Sedan Range

14-02

**TECHNICAL BULLETIN**

**Air Conditioning Pressure Cutout  
Switches – Schrader Valves Added –  
Revised Torque Setting**

ILLUSTRATION 1

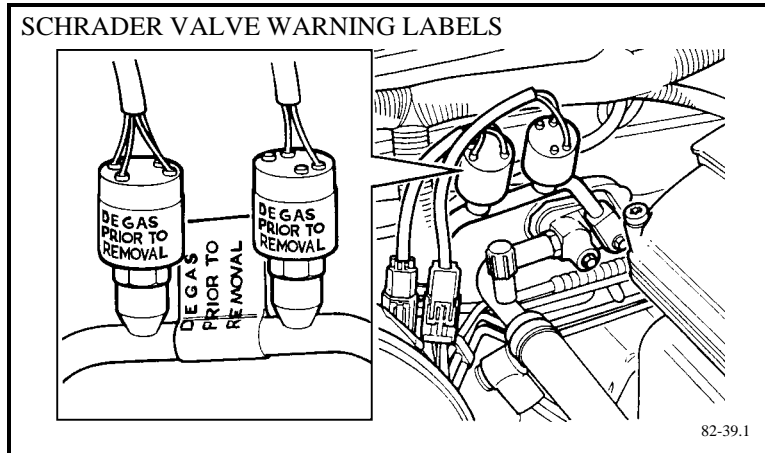
Vehicles within this VIN range may be labeled with a warning, “DEGAS PRIOR TO REMOVAL.” (Illustration 1)

Before removing the pressure switches on these vehicles always depressurize and recover the refrigerant.

- Depressurize both the high and low sides of the refrigerant system using approved R134a recovery equipment.
